UNITED STATES PATENT AND TRADEMARK OFFICE

10/766,829

Office Action Summary

DETAILED ACTION

FIG.1

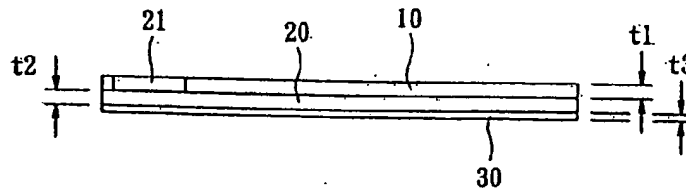
2. Figure 1 should be designated by a legend such as --Prior Art-- because only that which is old is illustrated. See MPEP § 608.02(g). Corrected drawings in compliance with 37 CFR 1.121(d) are required in reply to the Office action to avoid abandonment of the application. The replacement sheet(s) should be labeled "Replacement Sheet" in the page header (as per 37 CFR 1.84(c)) so as not to obstruct any portion of the drawing figures. If the changes are not accepted by the examiner, the applicant will be notified and informed of any required corrective action in the next Office action. The objection to the drawings will not be held in abeyance.

Drawings not acceptable. for 4/9/05
